Field Remedy: 2599

Subject: VIN-label - Wrong colour coding for Olympic White and Waterworld Blue

Models:	Engines:	Option:
Astra-J 2010	All	Olympic White,Waterworld Blue Met

I

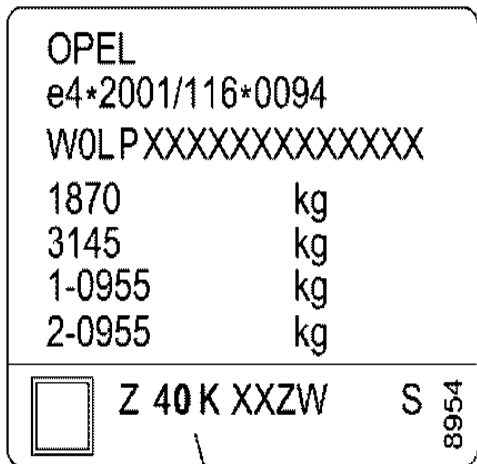
Complaint:	Wrong colour coding on VIN-label for Olympic White and Waterworld Blue.
Cause:	Due to a failure in colour code table all Olympic White and Waterworld Blue Met painted vehicles have incorrect paint codes on the chassis labels.
Production:	Only vehicles from plant Ellesmere Port until production date 02-Dec-2009 (VIN W0LPXXXXXX A 8 025917) with body colour Olympic White or Waterworld Blue are affected.

In case of customer complaint the colour coding on the VIN-plate has to be checked and if necessary replaced by a new VIN-plate.

1. Check colour coding on VIN-plate B-pillar (Picture I) and replace VIN-plate if colour code is incorrect

Important: To ensure the correct colour code on VIN-plate check the colourname by using the database "channel 21" and the VIN-Number.

Colour	RPO Code	correct Colour Code	incorrect Colour Code
Olympic White	GAZ	40R	40K (Yellow Punch)
Waterworld Blue Met	GEU	22A	224 (Signal Blue)
